SKAGIT RIVER HYDROLOGY INDEPENDENT TECHNICAL REVIEW DRAFT REPORT

Prepared for: Skagit County Department of
Public Works

Prepared by: Northwest Hydraulic Consultants

February 2007

Figure 1: High water marks and water surface profile for flood of 7 November 2006, Skagit River near Concrete

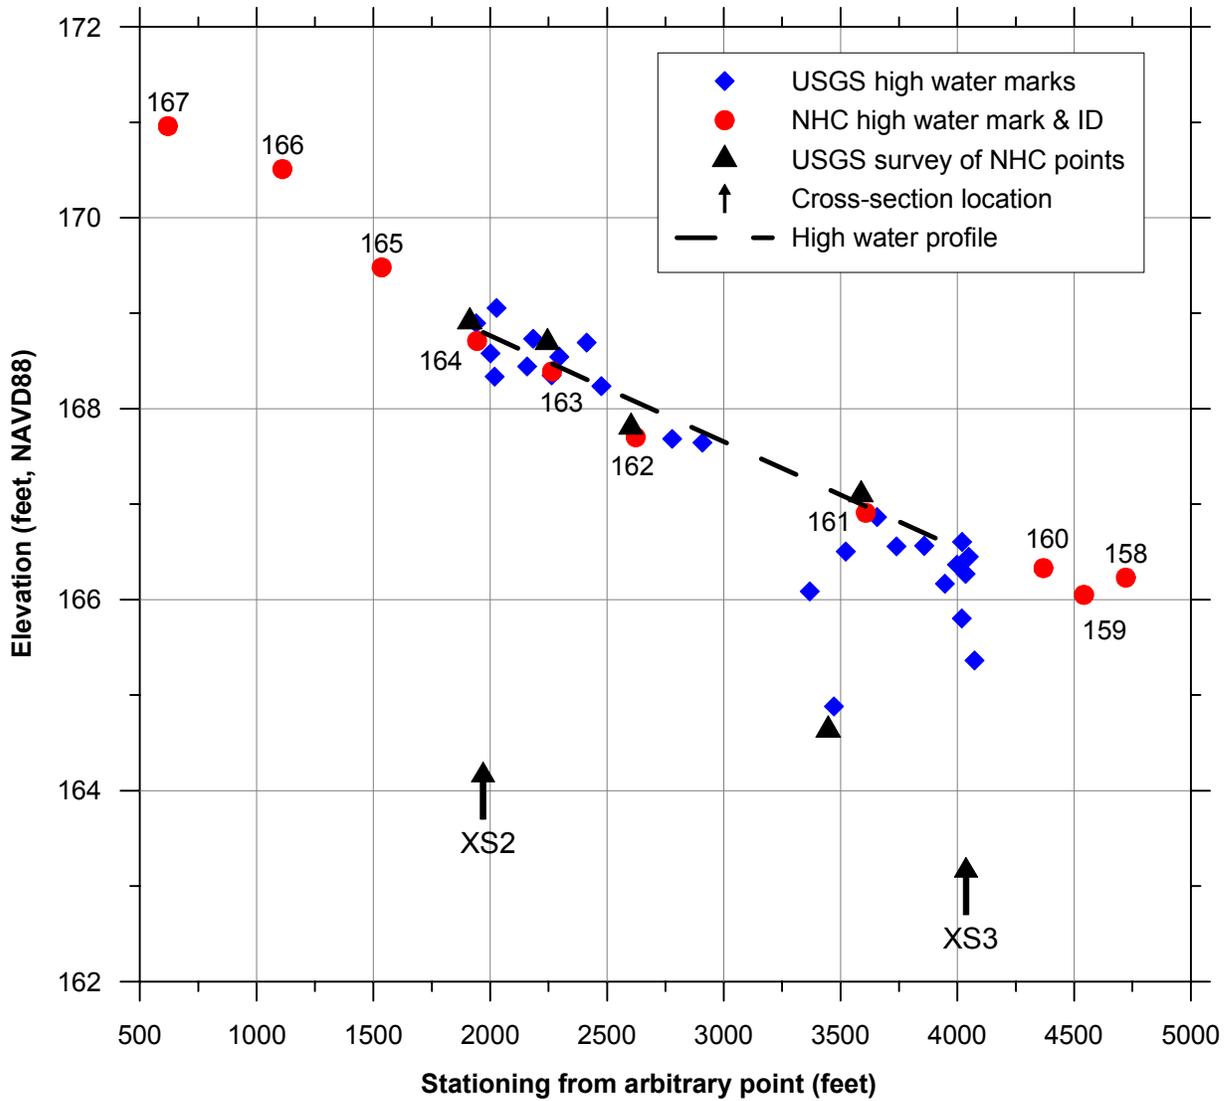
A water surface profile for the 7 November 2006 flood was staked by **nhc** for the reach in question approximately 10 hours after the peak discharge at Concrete, and high water marks for the event were staked by **nhc** a week later, on 14 November 2006. The staked points were subsequently surveyed by Skagit County. This work was restricted to the right bank because of difficulty accessing the left bank. The HWMs for this event were very obvious, identified primarily by strand lines of light debris at the edge of high water, and are considered to be accurate to within about 0.2 ft. HWMs for this event were also identified and surveyed by the USGS. The **nhc** and USGS data are plotted on Figure 1. Also shown on Figure 1 are the locations of USGS cross-sections 2 and 3, which define the reach used by the USGS in their 2004 “n” verification, along with a best estimate high water profile for the event.

The high water profile data of Figure 1 were used, with cross-section data from 2004 provided by the USGS, to estimate channel roughness for reach 2-3, following the procedures used by Mastin and Kresch (2005). The data were analyzed using the USGS

NCALC software (Jarrett and Petsch, 1985) to produce an estimate of “n” for reach 2-3 of 0.030.

Figure 2: Stage-discharge rating, Skagit River near Concrete

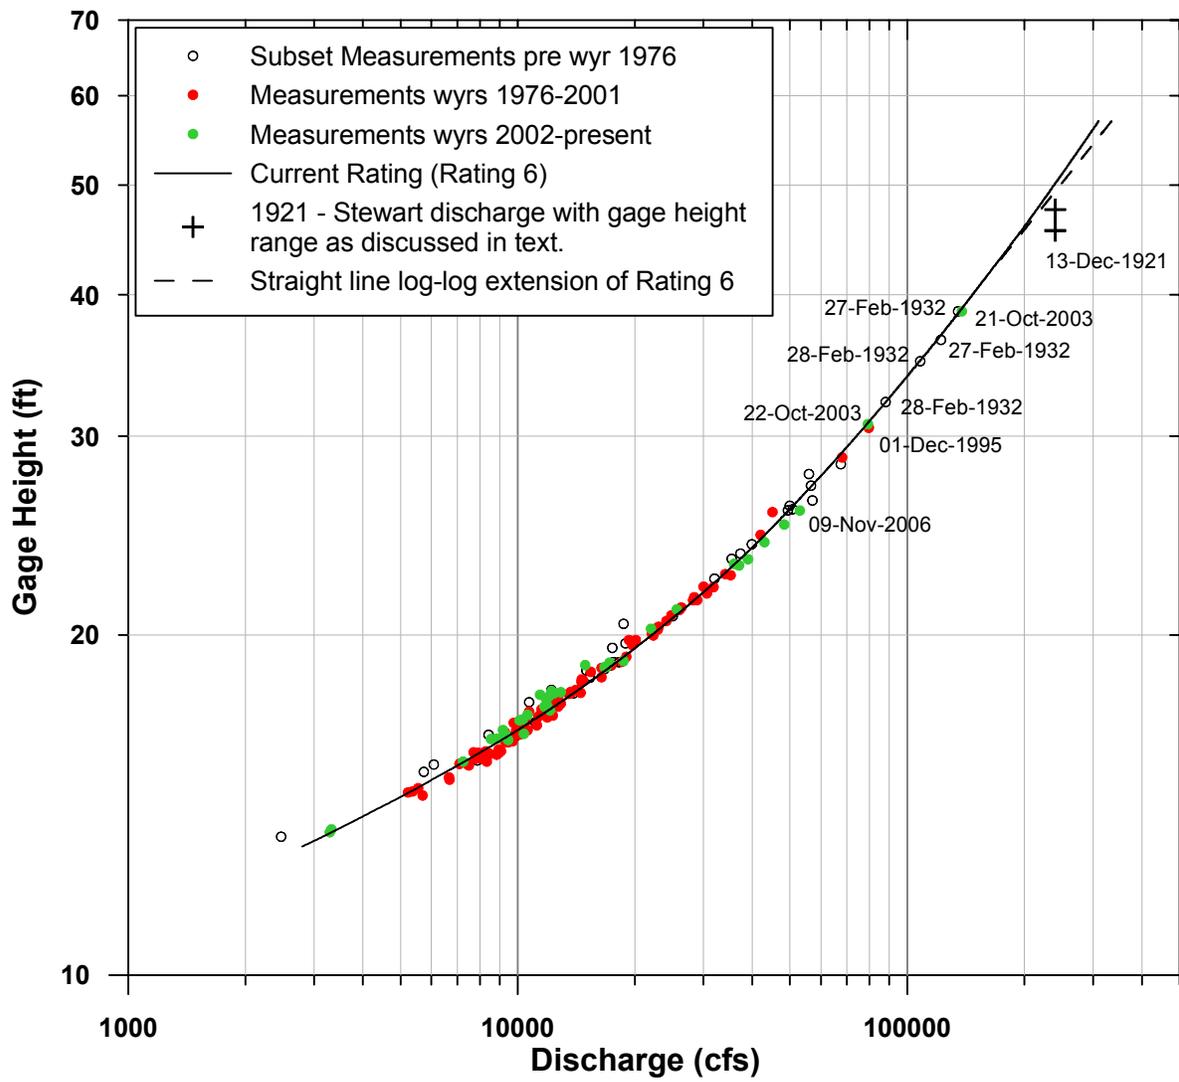
The Skagit River near Concrete gage has a well defined and stable stage-discharge rating which has been established through a comprehensive long-term program of discharge measurements. The current rating curve (Rating No. 6) is plotted in Figure 2 along with a selection of stage-discharge measurements. The discharge measurement for December 1921 is for the indirect measurement reported by Stewart. The corresponding gage height(s) shown in the figure for the December 1921 measurement are discussed below. All other measurements on Figure 2 are direct measurements (e.g. with a Price meter or more recently by ADCP) as reported by the USGS.

The top end of the stage-discharge rating (from around 80,000 cfs to 150,000 cfs is defined by a set of measurements taken during the flood of February 1932 (highest measured discharge 135,000 cfs, gage height 38.68 ft). A measurement taken in October 2003 (discharge 138,000 cfs, gage height 38.68 ft) agrees very closely with those of February 1932, confirming and validating the rating at least up to about 150,000 cfs. The close agreement between the highest measured discharge in February 1932 and the October 2003 measurement suggests that changed channel conditions downstream of the gage site (primarily changes in vegetation on the right bank gravel/cobble bar) have had no discernible impact on the stage-discharge rating at the gage site, at least for discharges up to 150,000 cfs. At this discharge, we estimate the bar to be covered by from 5 ft to 8 ft of water. The effect of the gravel/cobble bar on upstream conditions at the gage site can be expected to decrease at higher discharges because of the hydraulic control imposed by the contraction at The Dalles. Given the stability of the channel at the gage site, there is no reason to expect a material change in the high water rating between 1921 and present at this location.

The indirect measurement for the December 1921 event is plotted on Figure 2 using Stewart's discharge estimate but with two alternate "estimates" of gage height. The higher of the two gage heights shown for December 1921 is as published by the USGS and as determined by Stewart for the original site of the Concrete gage (reported to be 200 feet upstream from its current location) adjusted for the difference in datum between the original and current gage sites. The lower of the two gage heights shown for December 1921 reflects a further hypothesized adjustment of 2 feet to account for the water surface slope between the old and new gage sites. All other data shown on Figure 2 are taken from the current gage which was established in 1924.

Figure 3

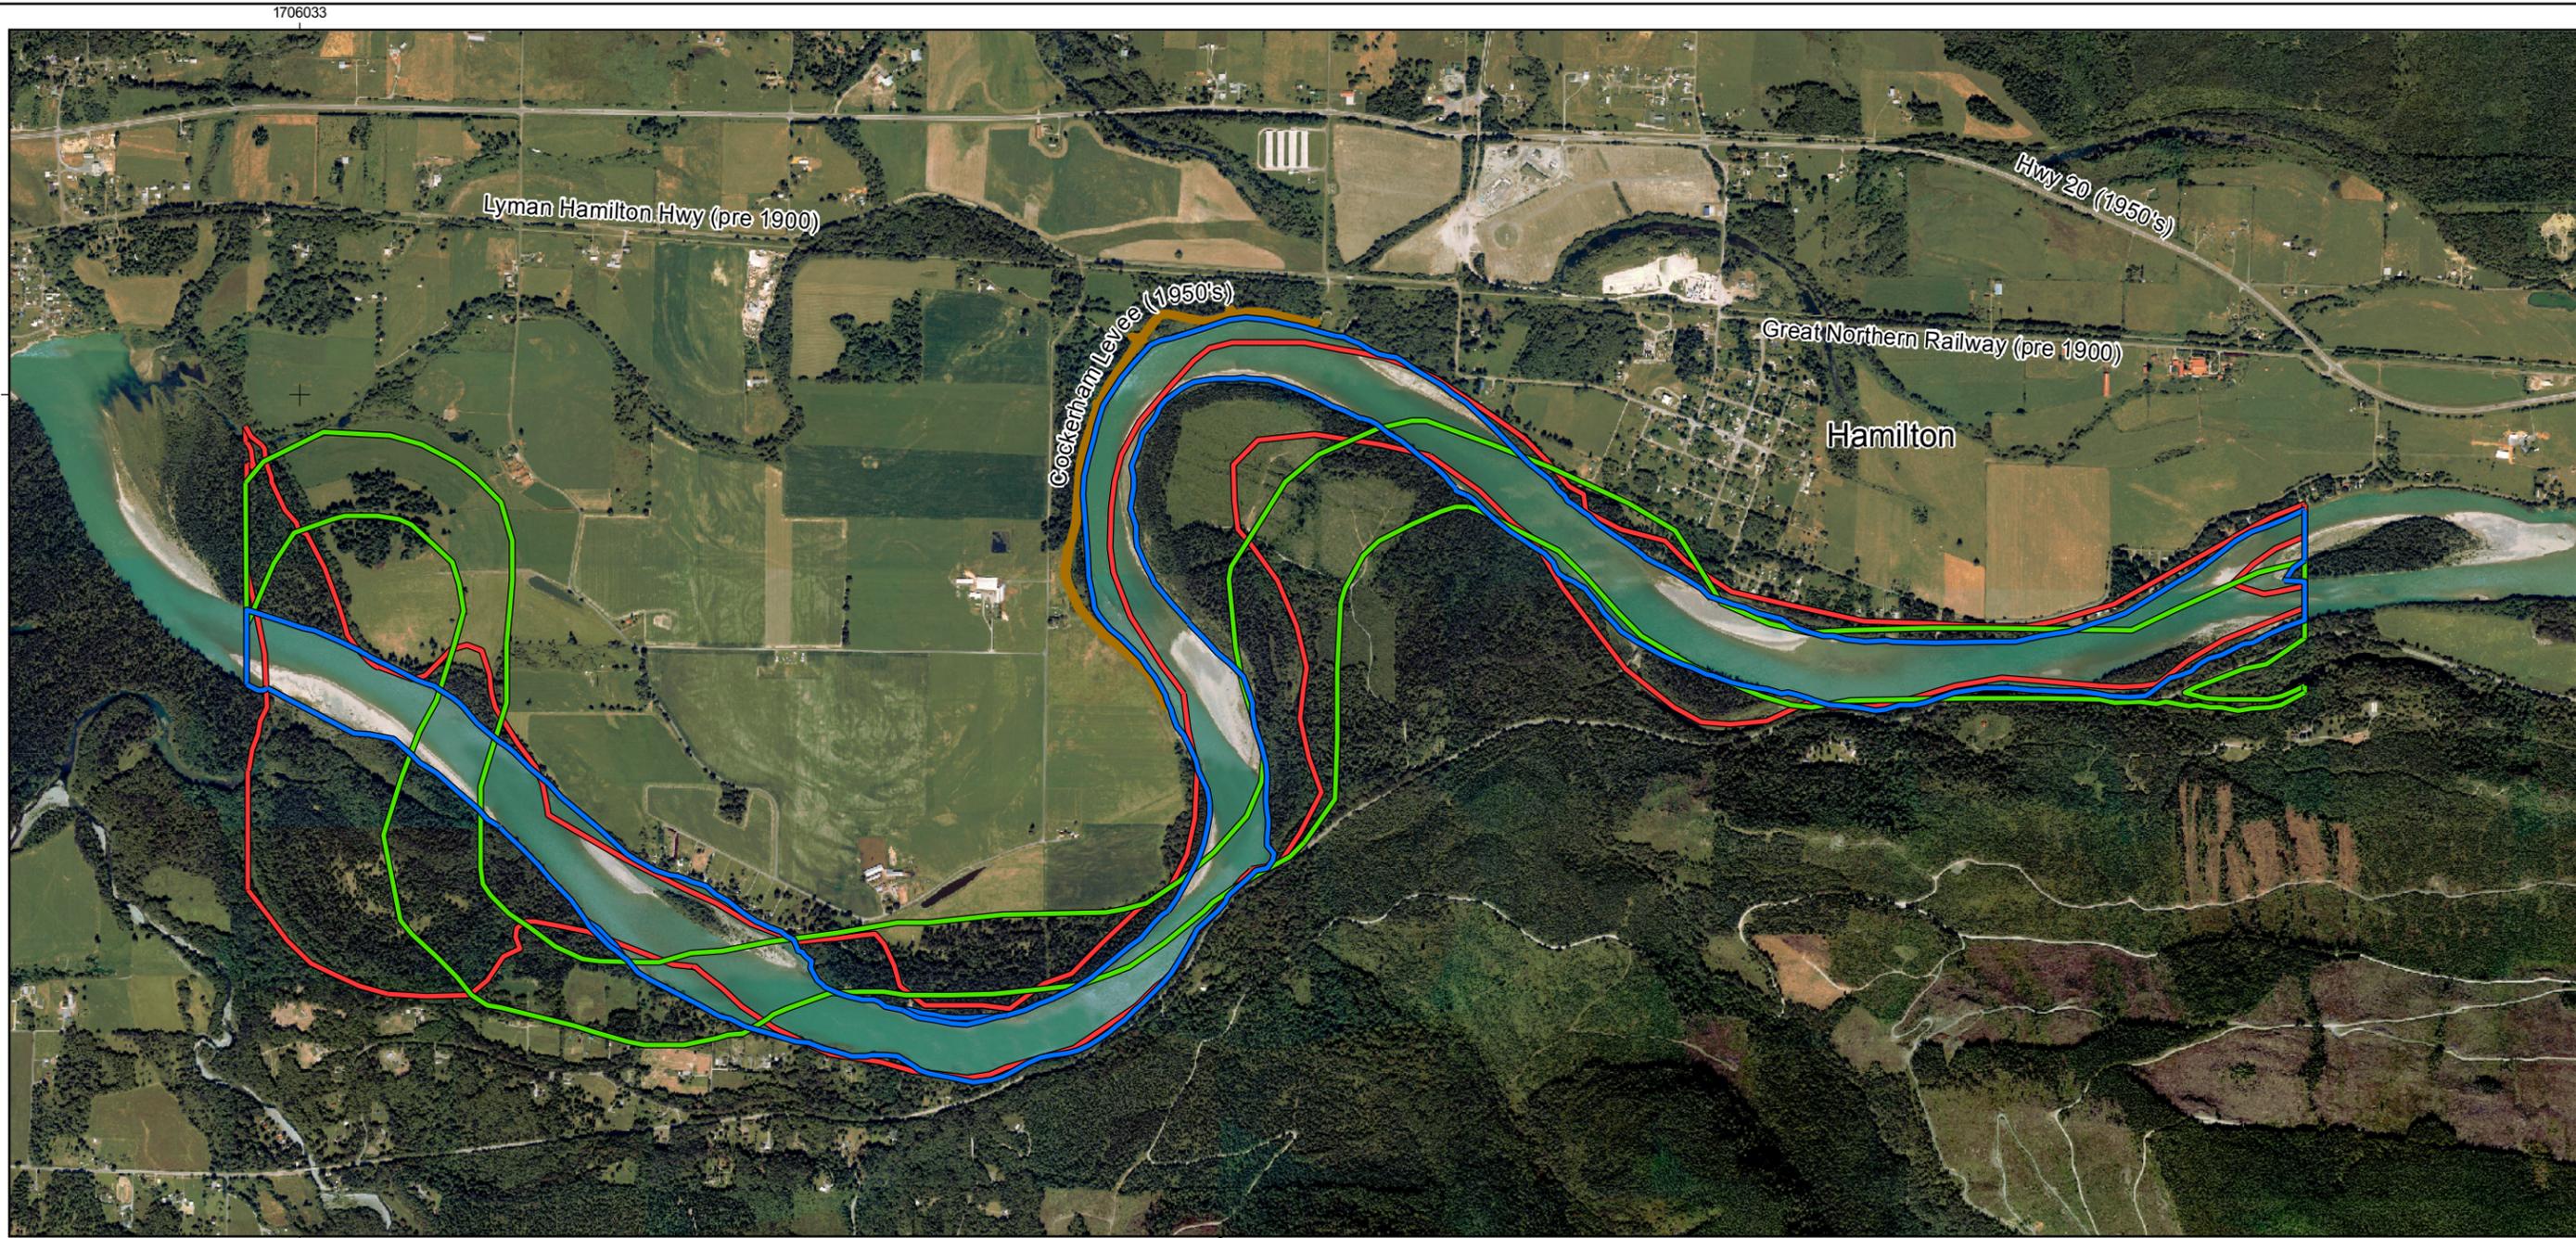
Figure 3 clearly shows a significant shift in channel planform between 1886 and 1937 downstream from Hamilton. The shift between 1937 and 2001 is much less pronounced.

Figure 3 also shows a substantial narrowing of the river channel downstream from Hamilton between 1937 and 2001. The average channel width for the approximately 1.5 mile reach through the first meander bend below Hamilton was about 750 ft in 1886 and 900 ft in 1937 compared with only 600 ft in 2001. These estimates should be used with some caution since: (1) we do not know with certainty how the river channel was delineated on the GLO maps, and (2) bank lines from the 1937 and 2001 aerials were drawn, in the absence of stereographic coverage, as the edge of continuous vegetation. The greater width in 1937 is due mostly to inclusion within the defined channel of a broad left-bank sand or gravel bar. Nevertheless the river channel in 1937 (and presumably also at the time of the historic floods) was clearly wider than at present and would have had a correspondingly greater conveyance capacity. Just how much greater is not possible to determine with any accuracy since detailed channel surveys from 1937 are not available.

Figure 4: Representative Section through Cockerham Levee (looking d/s)

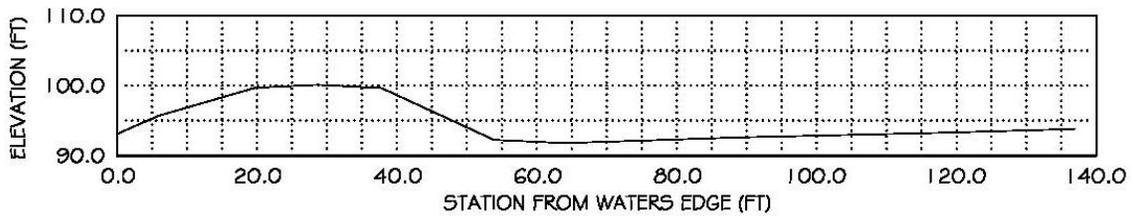
The Cockerham Levee (see Figure 2) is hydraulically a much more significant man-made feature than the rail line. A representative cross-section through the levee is shown in Figure 4. The levee confines flows downstream from Hamilton and prevents spill over the right-bank floodplain until the levee is overtopped or is otherwise breached, as appears to have been the case on a number of occasions in the past (most recently in November 2006). As far as we are aware, no hydraulic modeling or analyses have previously been performed to assess the impact of the levee on upstream water levels. Since the levee is not certified, it is not included in the hydraulic models developed by the Corps for the current flood insurance study. An approximate analysis of the impact of the levee on water levels in Hamilton at RM 39.8 was undertaken as part of this review. A simple representation of the levee was included in the Corps' final HEC-RAS model and the model was then run with and without the levee for a flow of 160,000 cfs, as reported at Concrete for the November 1995 flood, and for a flow of 240,000 cfs, as published for the December 1921 flood and also, coincidentally, the current estimate of the 100-year regulated discharge at Hamilton. The results are summarized below:

The approximate analysis conducted for this review indicates that the Cockerham Levee raises water levels in Hamilton by about 1.2 ft for flows in the range of 240,000 cfs. With the levee in place and assuming that the Smith House was just flooded to the level of the main floor at a discharge of 160,000 cfs in November 1995, then a discharge of 240,000 cfs **with the present channel conditions**³ would have flooded the house to a depth of about 4.2 ft. Without the levee but **with present channel conditions**, the depth of flooding would have been about 3.0 ft. Given that the river below Hamilton was considerably wider in 1937 than today, it is possible that the river could have carried 240,000 cfs in 1921 without flooding the main floor of the Smith House. More definitive estimates of water levels at the Smith House during the December 1921 flood are not possible given the lack of detailed channel geometry data from that period.

Figure 6: 100-year Regulated Peak Discharge Profiles

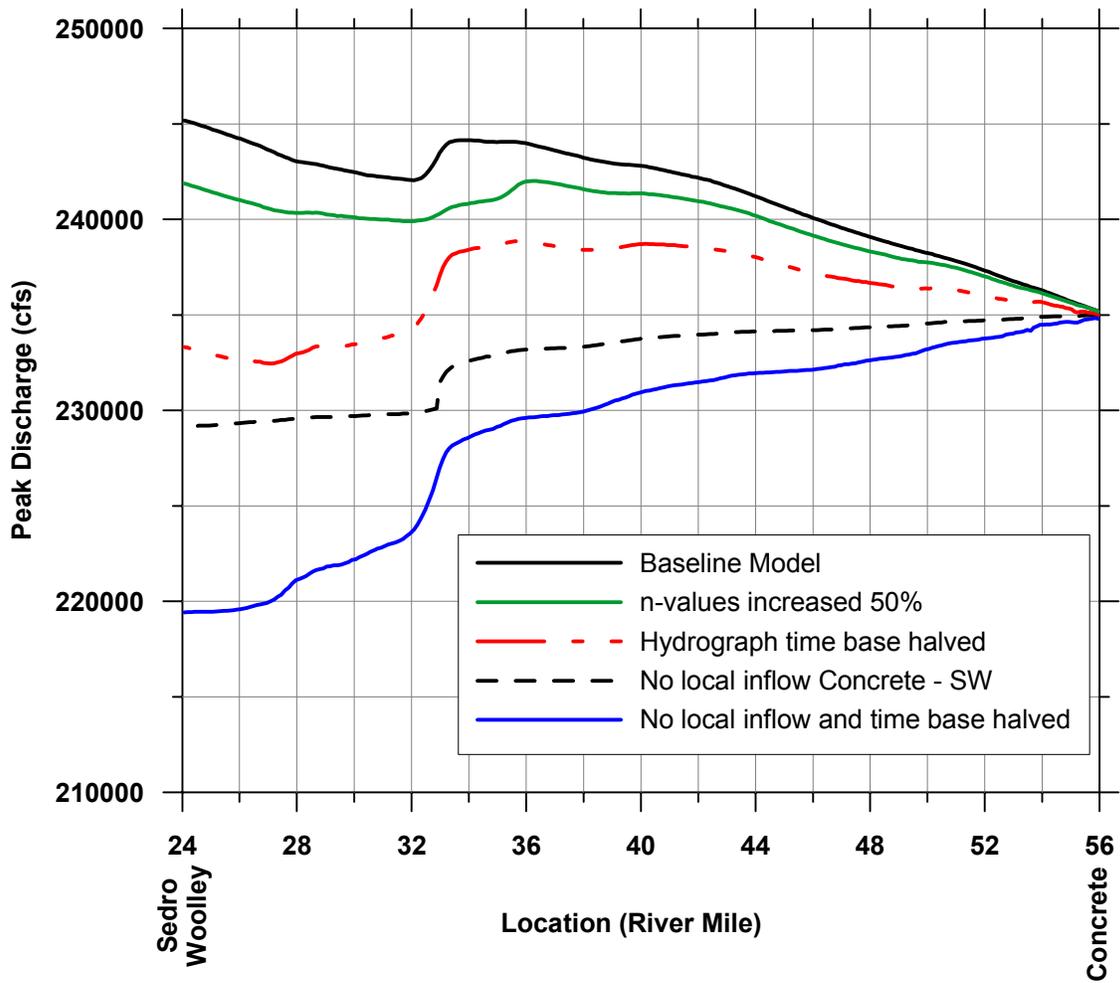
The results of the sensitivity runs are summarized in the peak discharge profile plot of Figure 6.

Even with the most extreme of the above scenarios (no local inflow between Concrete and Sedro-Woolley and the time base of the hydrographs halved) it is not possible for the hydraulic model to reproduce the attenuation implied by the historic flood data from

Concrete and Sedro-Woolley, which strongly suggests that either the historic peak discharges reported for Concrete are too high or the corresponding discharges reported at Sedro-Woolley are too low.

Figure 7: Annual Frequency Analysis, Skagit River near Concrete Unregulated Instantaneous Peak Discharge – Run 3

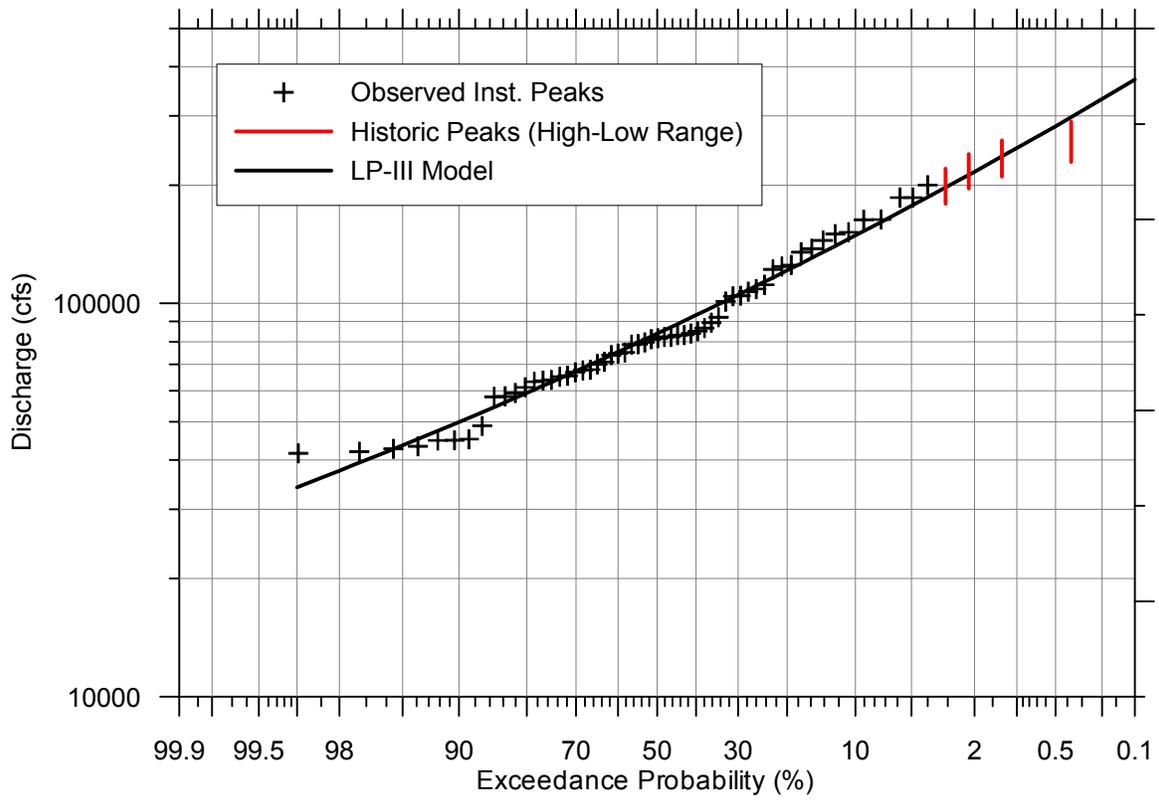
The frequency curve as estimated by EMA with uncertain historic data values together with the discharge data is shown in Figure 7. With the above range of discharges for the historic floods and assuming that the 1898 flood is the largest in the period 1870 to 1898, the estimate of the 100-year unregulated discharge is reduced from 284,000 cfs to 248,000 cfs.
